Firmware Update 3.0 – MSA G1 SCBA

G1 SCBA Firmware 3.0 Graphics Changes

Shutdown Screen

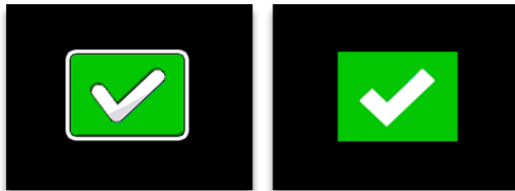
- Enhanced Power icon animation; flashes blue-gray with a left-to-right decreasing progress bar
